**OFFICE OF ENVIRONMENTAL
SUSTAINABILITY**

**INSPECTOR'S REPORT ON AN APPLICATION
FOR A CERTIFICATE OF AUTHORISATION
FOR A CLOSED LANDFILL**

TO:	Micheál Lehane, Director
FROM:	Ewa Babiarczyk, Inspector, Environmental Licensing Programme
DATE:	29 th March 2021
RE:	Application by Fingal County Council for a Certificate of Authorisation for a closed landfill at Barnageeragh Cove, Skerries, County Dublin . Certificate of Authorisation Register Number H0167-01 .

Figure 2: Site layout and site surroundings

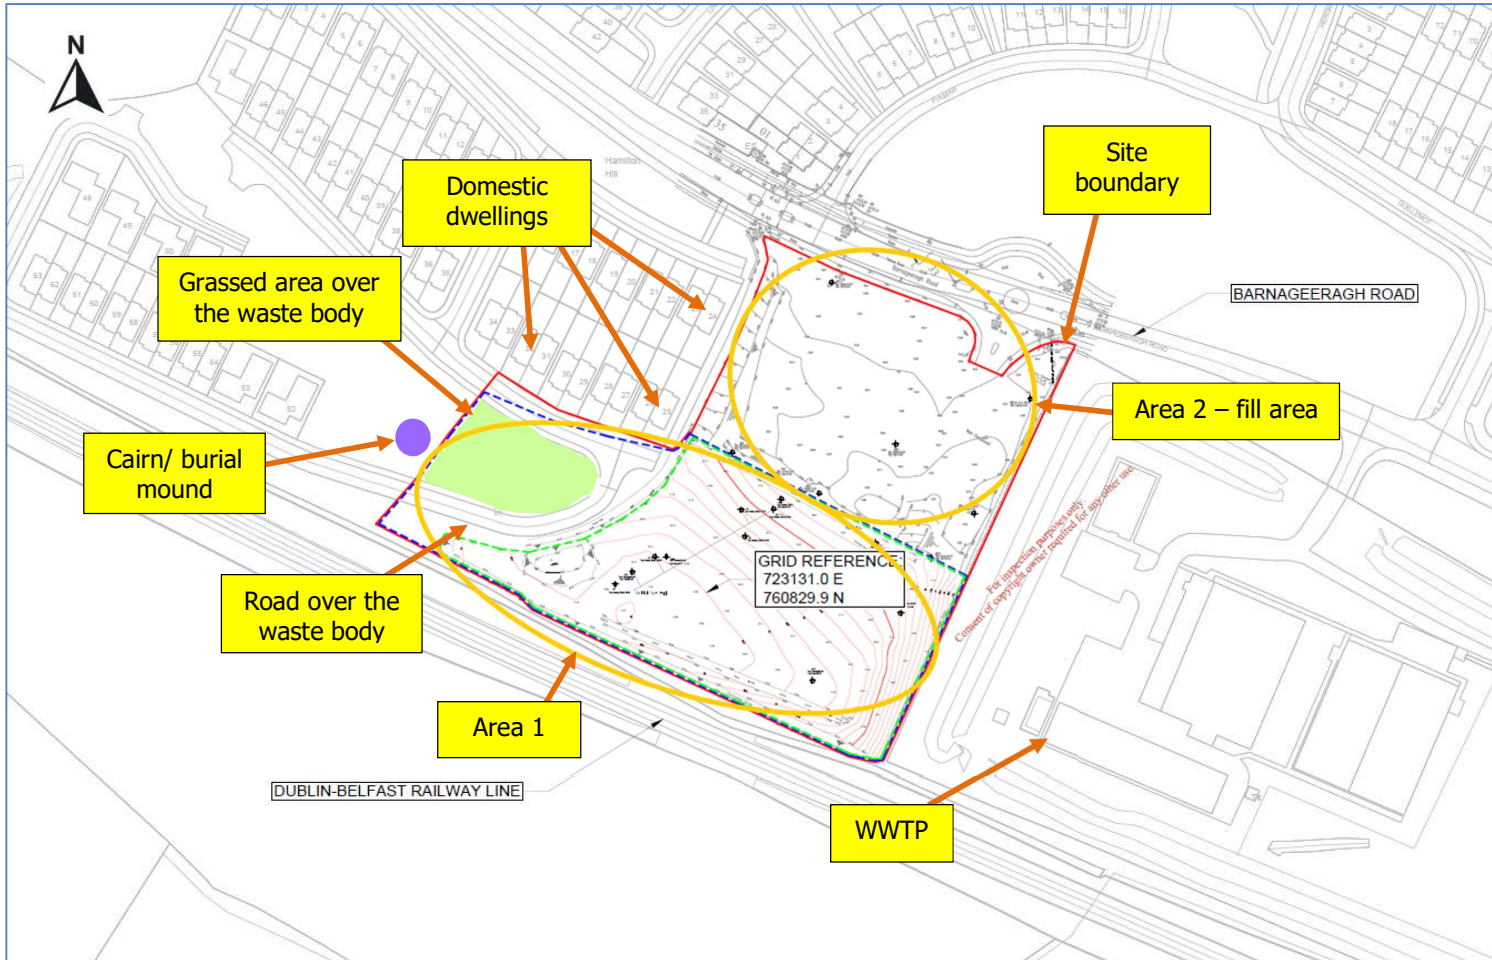
Considering however the fact that hazardous waste was deposited in the waste body beneath the grassed area opposite the houses shown in Figure 2, the infiltration of rainwater into the waste body and the negative impact the waste body is having on groundwater, Condition 3.1(b) requires installation of an engineered landfill cap also over this grassed area.

Figure 6: Trial pit (METP), groundwater/gas monitoring borehole (BH), gas vent (GV) and shallow gas well (GS) monitoring locations

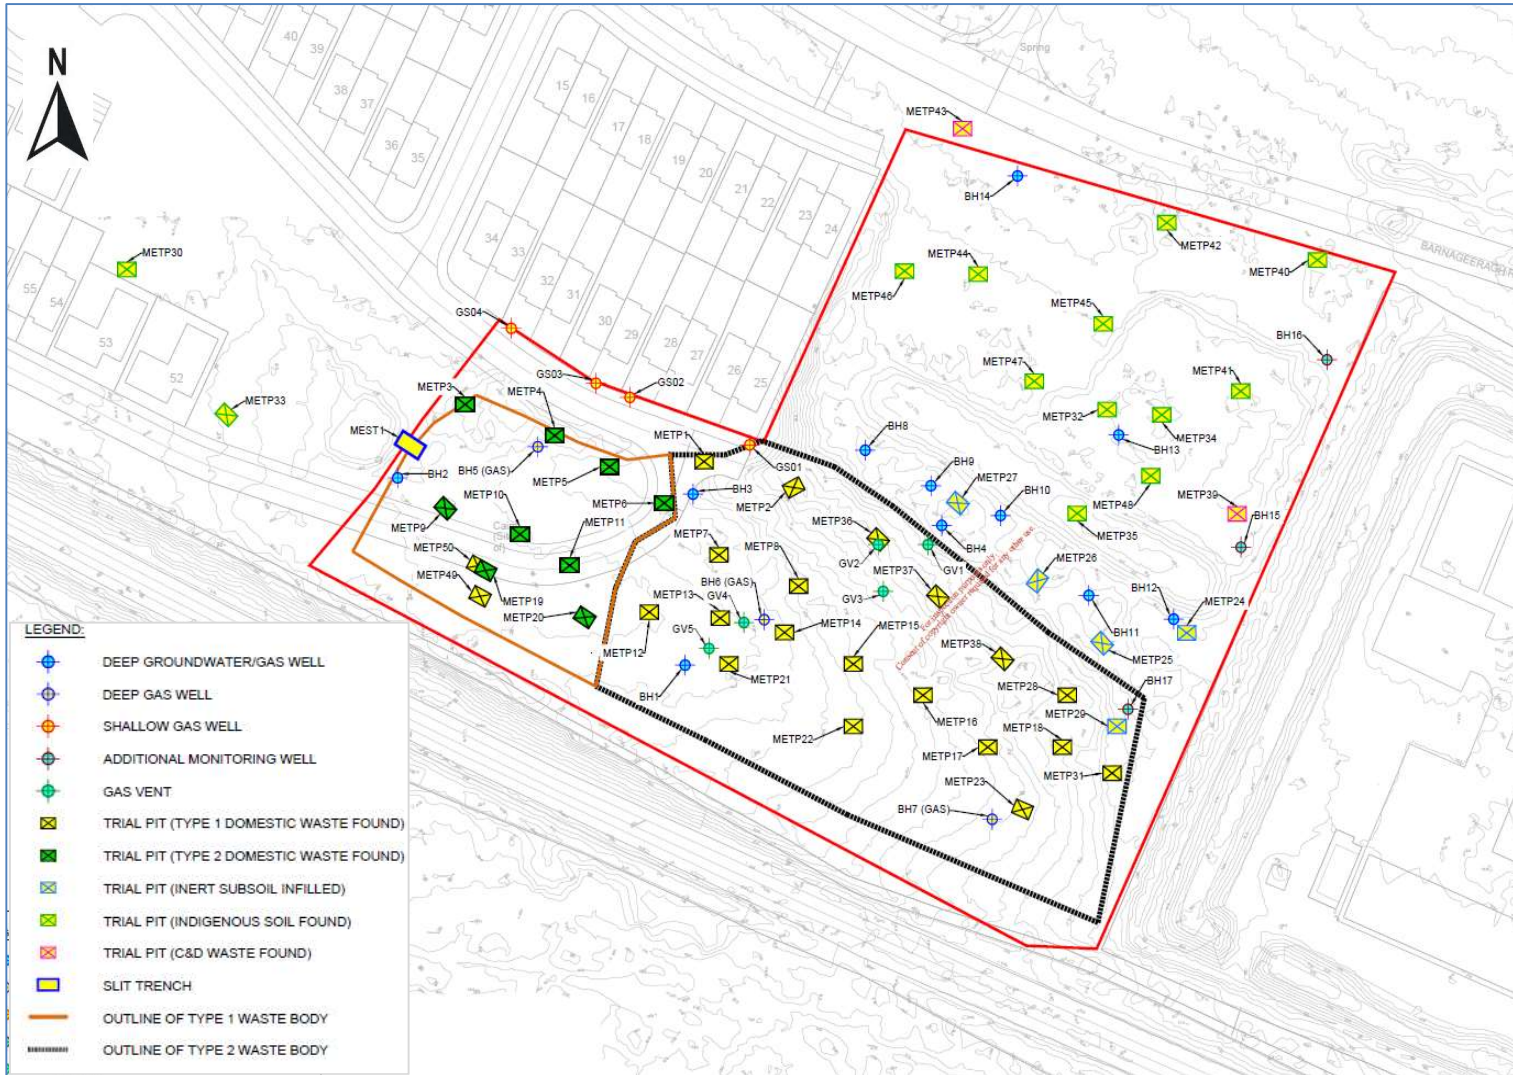
It is also noted that no gas monitoring took place near house No. 24 which is located immediately adjacent to Area 2, as shown in Figure 6. Having regard to the fact that landfill gas was detected within Area 2, it is considered appropriate to monitor gas at this house. Accordingly, Condition 3.1(d)(i) requires installation, within Area 2, of one gas monitoring borehole (GS05) near house No. 24.

Additionally, it is noted that no gas monitoring took place between Area 1 and house No. 52. Accordingly, Condition 3.1(d)(ii) requires installation of one gas monitoring borehole (GS06) near house No. 52.

It is noted that the recommended monitoring does not include boreholes in the western part of the waste body or other boreholes shown in Figure 6. Therefore, in addition to the recommended monitoring from the Tier 3 Assessment, Condition 3.9(c) requires gas monitoring in the vent stack(s), BH15 and the proposed boreholes, GS05 and GS06, near house No. 24 and house No. 52 respectively. Additionally, Condition 3.1(d)(iii) requires installation of additional gas monitoring boreholes between the cut-off trenches and the adjacent houses to demonstrate the effectiveness of the cut-off trenches, if required by the Agency. Gas monitoring at these boreholes and at the existing infrastructure (radon sumps & water mains meters) of the adjacent houses No. 24 to 34 and house No. 52 is also provided for in Condition 3.9(c).

- (i) One gas monitoring borehole (GS05) within Area 2 near house No. 24;
- (ii) One gas monitoring borehole (GS06) near house No. 52; and
- (iii) Additional gas monitoring boreholes between the gas cut-off trenches and the adjacent houses, if required by the Agency to assess the effectiveness of the trenches in preventing lateral gas migration.

Figure 8: Proposed gas management system and surface water run-off drainage system

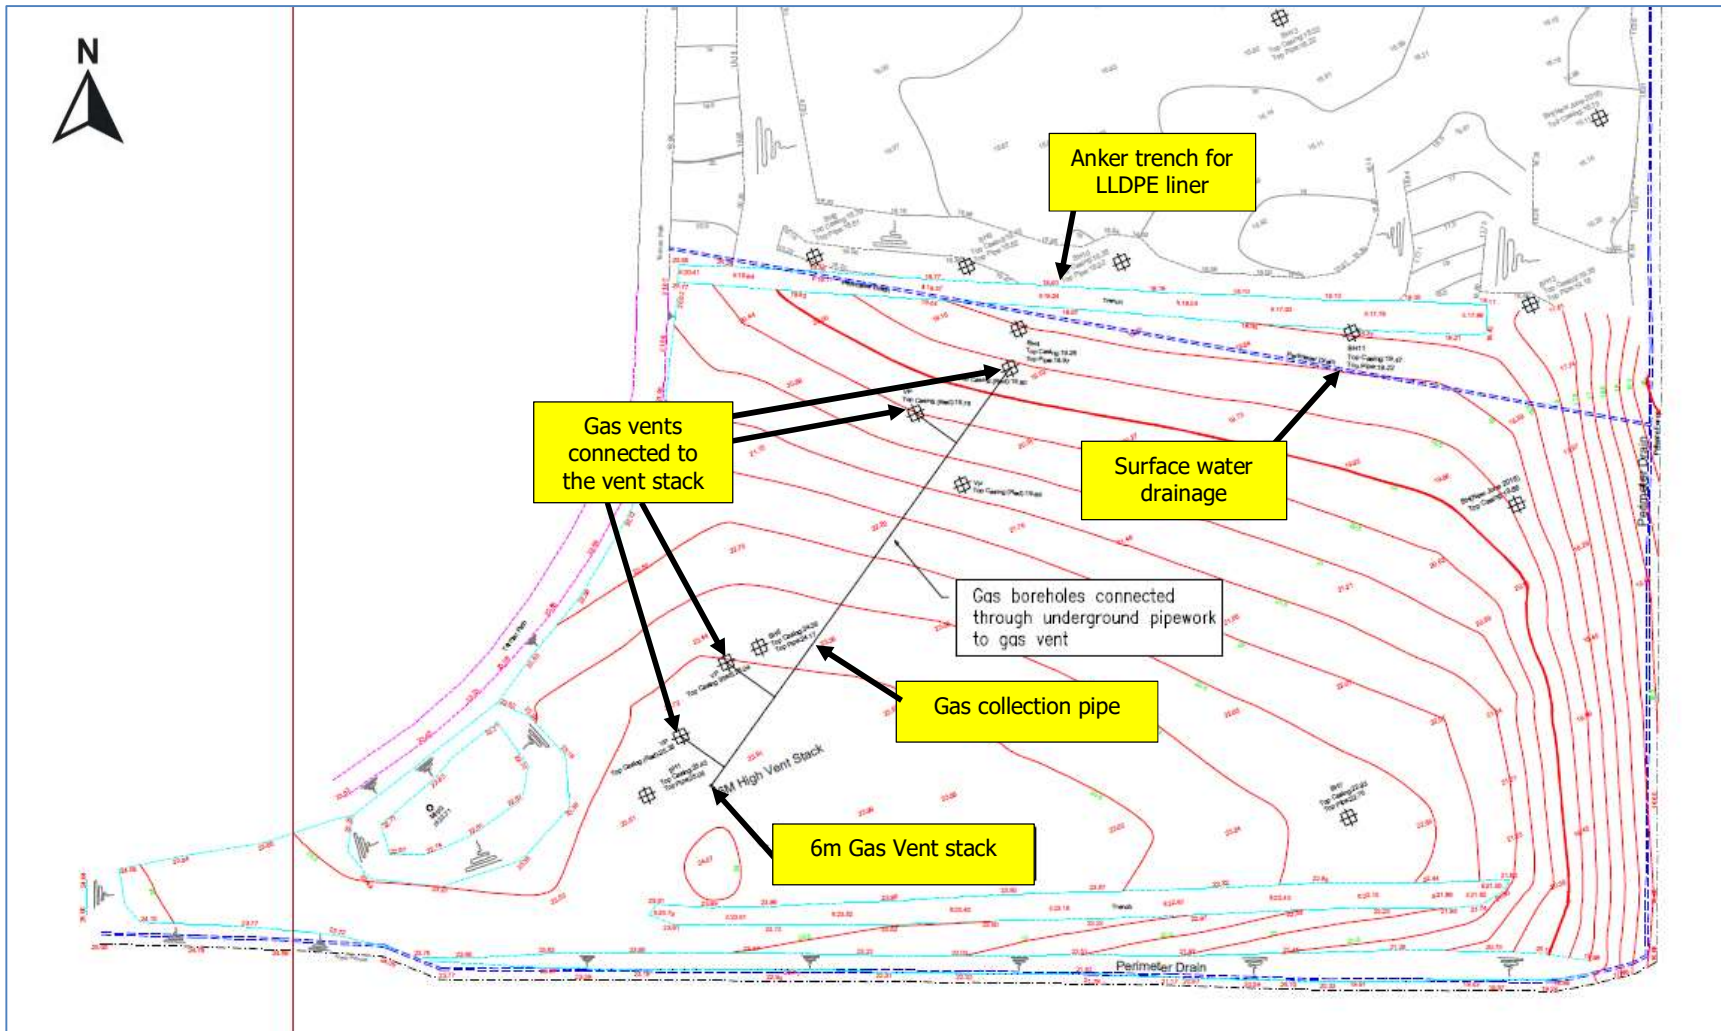
concentrations were elevated at numerous monitoring locations, it is considered that the installation of a gas venting system in only one section of the site is insufficient. Accordingly, Condition 3.1(c) requires the installation of a passive gas venting system within all of Area 1 where waste is deposited and in the made ground in Area 2 within six months of the date of grant of the Certificate of Authorisation. Additionally, the passive gas venting system must include locations outside of these areas where elevated gas concentrations were recorded (>1.0% methane, >1.5% carbon dioxide). It is also considered that additional gas vent stacks may be necessary due to the number of locations where gas was detected, accordingly Condition 3.1(c)(ii) provides for additional gas vent stacks if necessary. Additionally, Condition 3.5 requires an updated drawing showing the gas collection management system.

Furthermore, considering that landfill gas migrates from the waste body into Area 2 and to adjacent houses and the fact that methane in the landfill gas presents a fire or explosive threat, Condition 3.1(c)(iii) requires the installation of an engineered cut-off trench between the waste body and the houses adjacent to Area 1 (house No. 25 to 32) and, if required by the Agency based on gas monitoring results, between the waste body in Area 1 and house No. 52 and between the made ground in Area 2 and the houses along the western boundary of Area 2 (house No. 25 & house No. 24). Condition 3.1(c)(iii) further requires that the cut-off trench is filled with gravel and lined from the houses side with a high-density polyethylene (HDPE) liner. Condition 3.1(c)(iii) further requires that the base of the cut-off trench is constructed to the maximum depth of the deposited waste.

- Installation of a surface water drainage geocomposite to intercept surface water and construction of surface water drains as shown in Figure 8. The risk assessment recommends that surface water drains are constructed around the perimeter of the capped area and discharge to the Eastern Stream at the north-eastern corner of the site.
- Placement of a minimum of 1m thick soil layer comprising 850mm of clean subsoil overlain by 150mm clean topsoil.

- (i) gas vent pipes with cowls for gas extraction. The gas vent pipes shall not be perforated above the ground level;
- (ii) 6m high gas vent stack(s) and associated underground gas collection pipe(s);
- (iii) Gas cut-off trench in the following areas:
 - Between the waste body in Area 1 and houses No. 25 to No. 32 adjacent to Area 1;
 - If required by the Agency, following gas monitoring for a period of twelve months as required under Condition 3.9(c), between the waste body in Area 1 and house No. 52; and
 - If required by the Agency, following gas monitoring for a period of twelve months as required under Condition 3.9(c), between the made ground in Area 2 and houses No. 24 to No. 25.

- The base of the gas cut-off trench shall be constructed at the maximum depth of the deposited waste; and
- The gas cut-off trench shall be filled with gravel and have a high-density polyethylene (HDPE) liner installed on the houses side of the gas cut-off trench, unless otherwise agreed by the Agency.

Figure 9: Area proposed to be capped

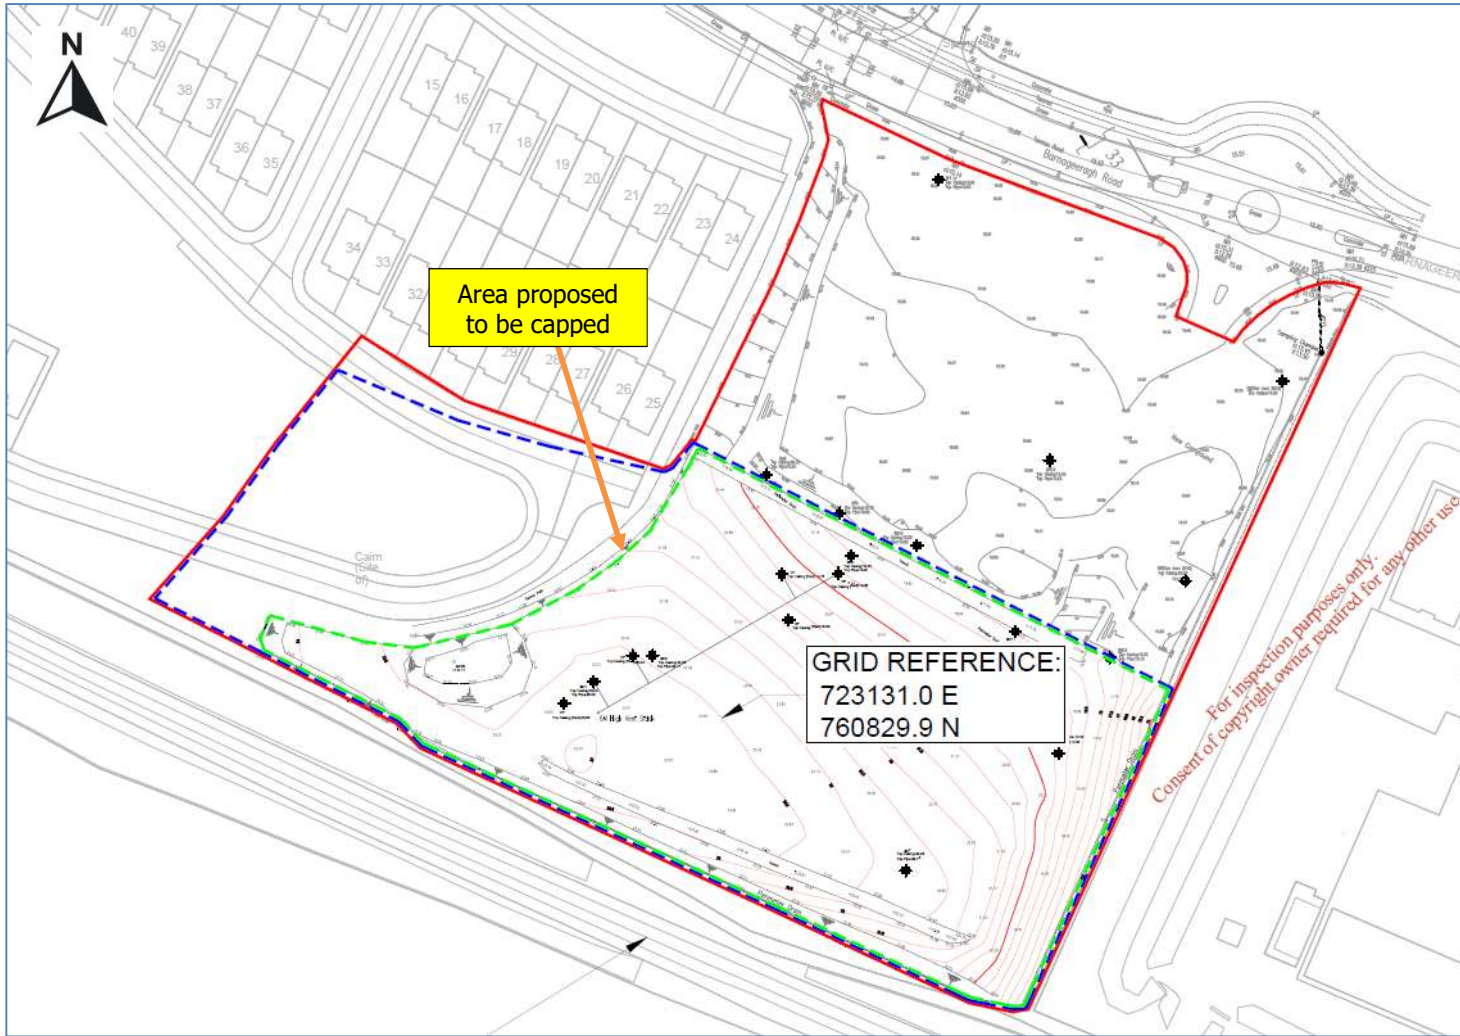
- Installation of a low permeability barrier layer (permeability to be less than or equal to 1×10^{-9} m/s) to cover part of the waste body in Area 1, as shown in Figure 9. The risk assessment recommends that the low permeability layer should be a geomembrane, such as 1mm linear low-density polyethylene (LLDPE).

- (a) Minimise the disturbance of deposited waste to the extent possible;
- (b) Install a low permeability landfill cap, minimum 1m, with 1mm thick low permeability geomembrane having a hydraulic conductivity of less than or equal to $1 \times 10^{-9} \text{m/s}$; The landfill cap shall be installed over the waste body, as shown on Drawing No. MGE0755-RPS-00-XX-DR-C-DG0001-02 (Revision F01 dated 13/11/20) titled 'Barnageeragh historical landfill site location map - contour map', and over the grassed area opposite houses No. 27 to No. 32.
- (c) Install passive gas venting system, in the following areas within six months of the date of grant of this Certificate of Authorisation:
